Ref: 0536r01v03

**RE: 18 – 20 THE SERPENTINE, BILGOLA BEACH
DEVELOPMENT APPLICATION FOR THE CONSTRUCTION OF A STUDIO AND CAR PARKING STRUCTURE
PARKING DESIGN STATEMENT**

A Pre-lodgement meeting (ref: PLM 2021 / 0305) was held on the 09/12/2021 between the Applicant and Council's representatives with a number of aspects discussed relating to the Proposal including parking design. Council's comments are reproduced below, which are highlighted, for reference.

DRAWING TITLE
SITE PLAN + SITE ANALYSIS
PROJECT NO.
2236
SCALE
1:200 @ A1

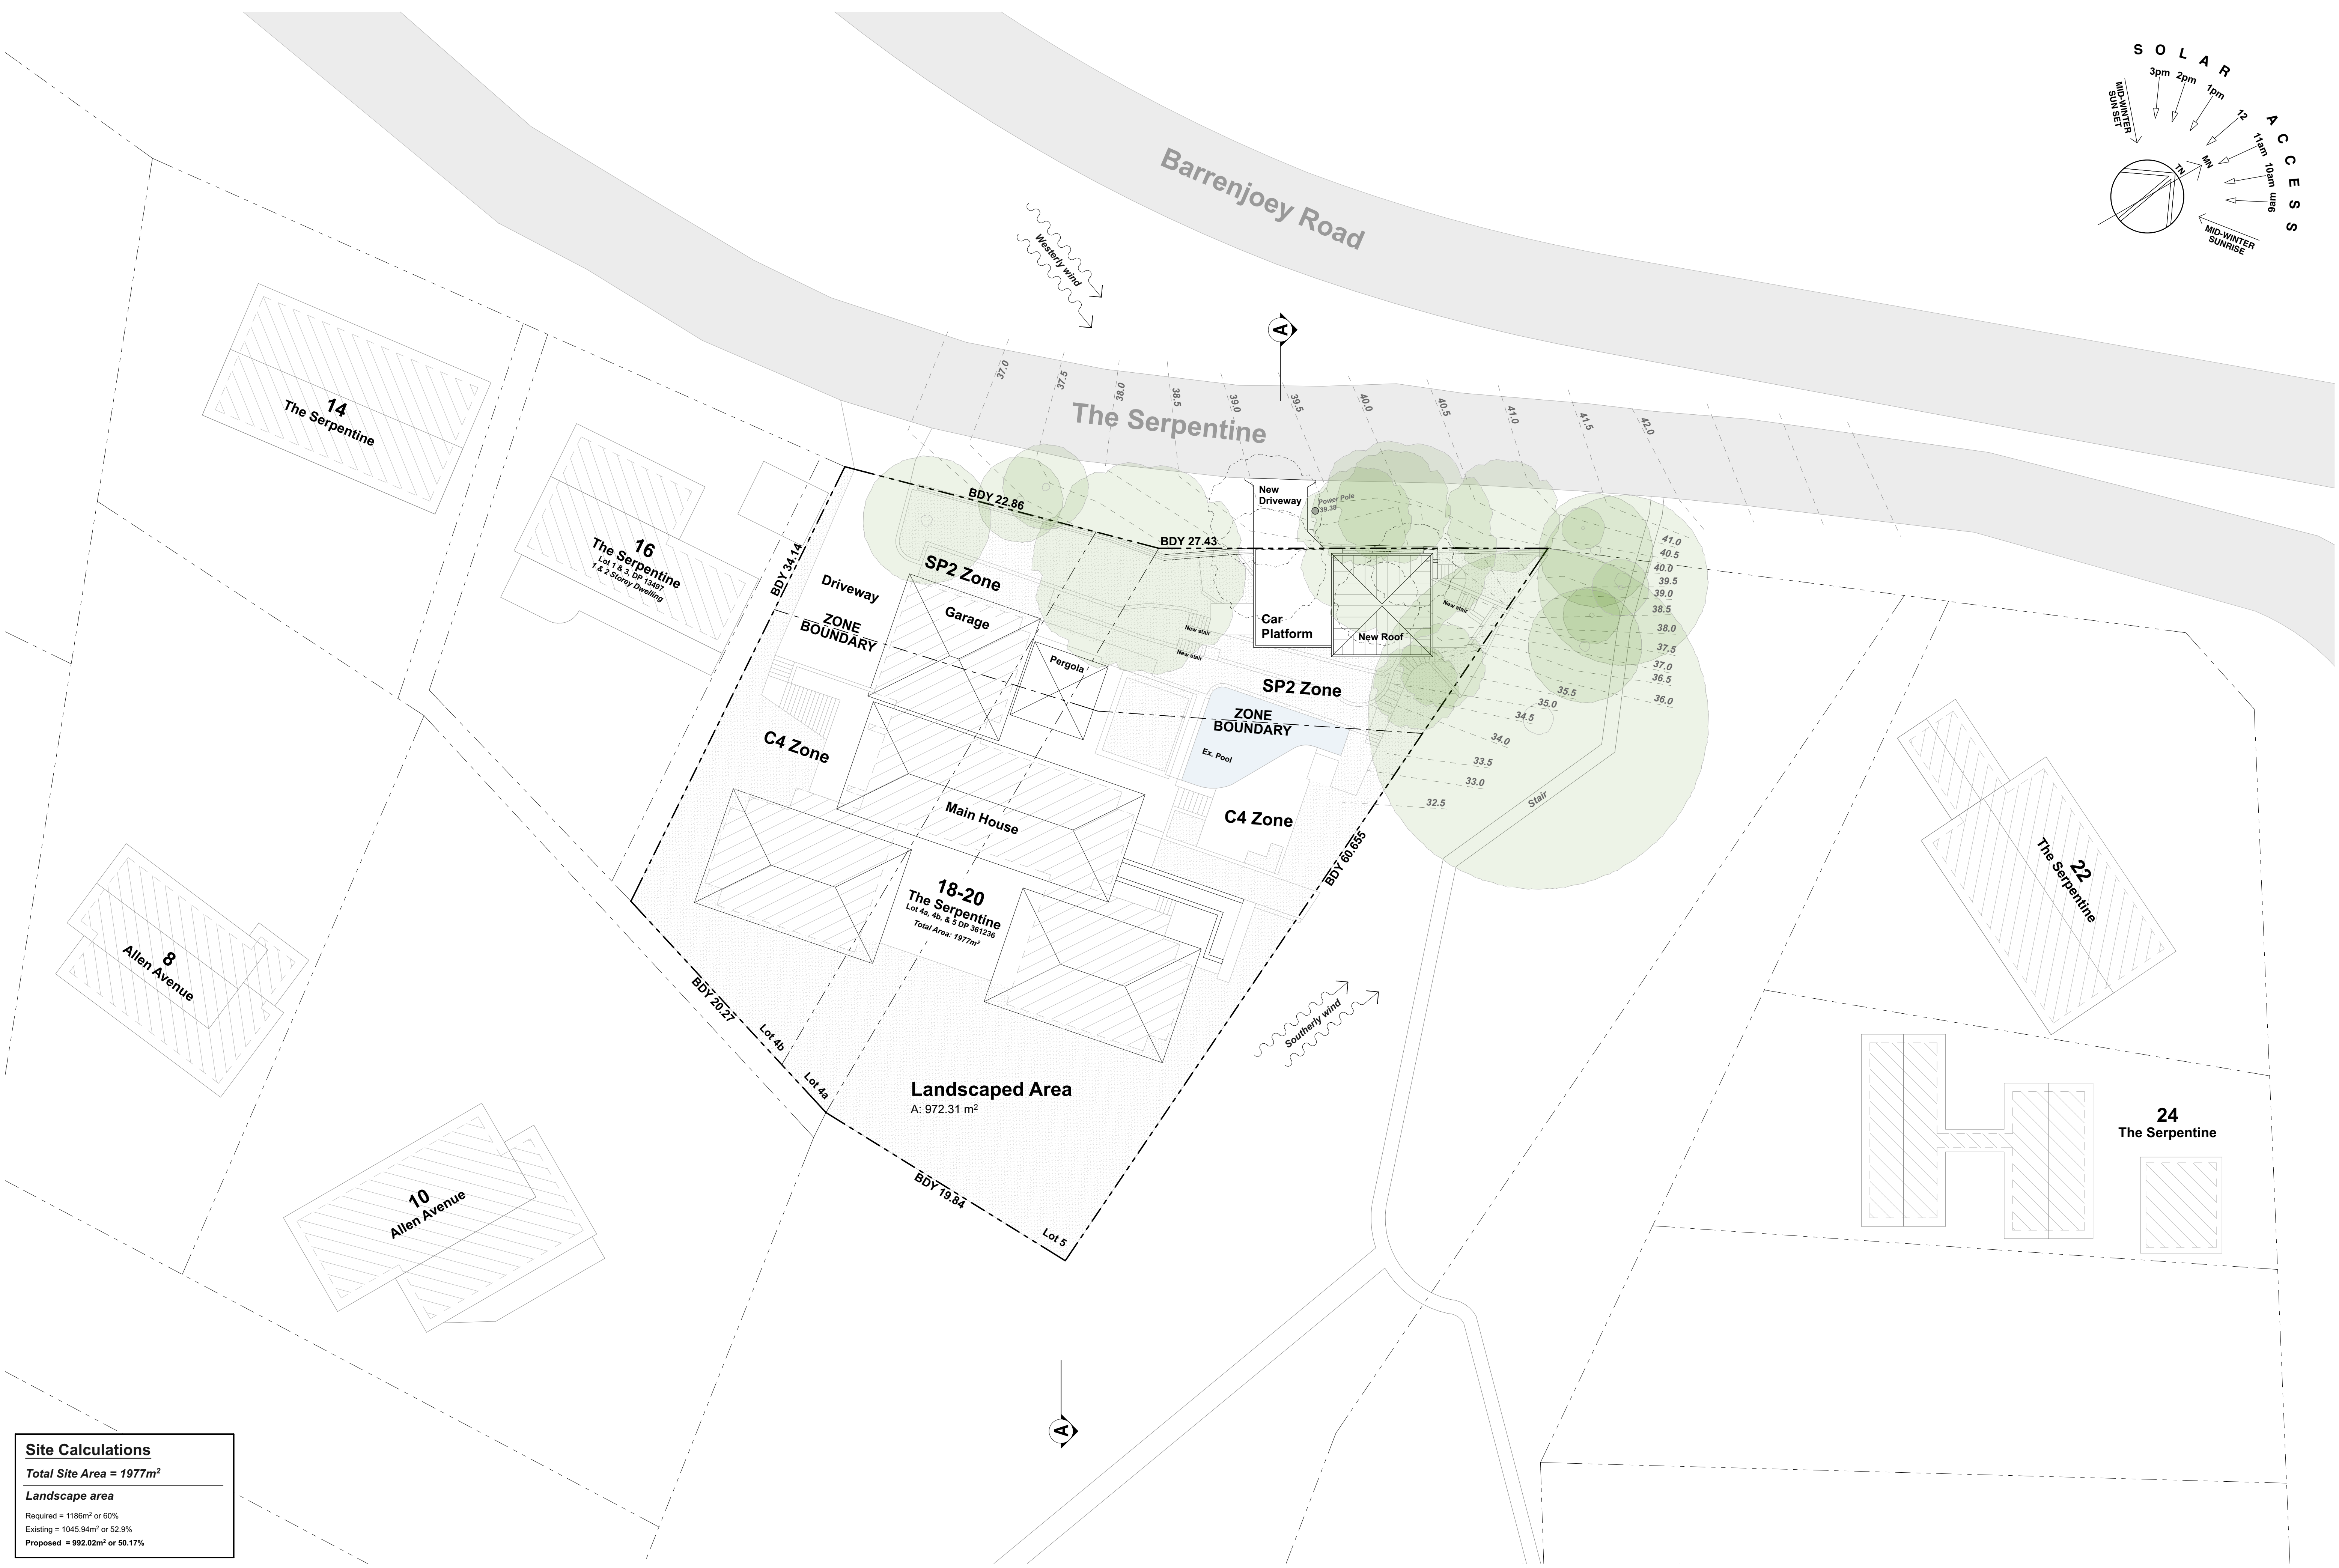
The applicant is to provide a site line analysis to address traffic safety for the proposal given the proximity to the road bend. Should the site line analysis recommend additional tree removal, the arborist report must take this into consideration. Please refer to Council's landscape officer comments regarding tree removal in the Council reserve.

3. The driveway grades must be in accordance with Council's standard drawing A4/330/3 NL. Sections through the proposed crossing are to be submitted demonstrating compliance. The 1:4 Max grade shown on the submitted drawings must include a transition in accordance with the above standard drawing. This will require the proposed parking area to be raised to suit.

4. As the driveway is elevated, barriers in accordance with AS/NZS2890.1:2004 must be provided for the driveway and parking structure. The above-mentioned Traffic Engineer's report must take into account the barrier walls in the sight distance assessment.

As demonstrated by the architectural drawings included as **Attachment 1**, the Proposal will include pruning of the underside of the trees and removal of shrubs and any other visual obstacles to the northeast of the driveway along the site frontage, resulting in improved sight lines along the The Serpentine to the northeast the proposed vehicle access.

- AS 2890.1 requires that barriers are required along the edges of the driveway wherever a drop from the edge of the deck to a lower level exceeds 600mm. The architectural drawings included in **Attachment 1** shows that the road reserve on both sides of the proposed driveway will be battered to eliminate the drop in level. Barriers are therefore not required along the edges of the driveway.
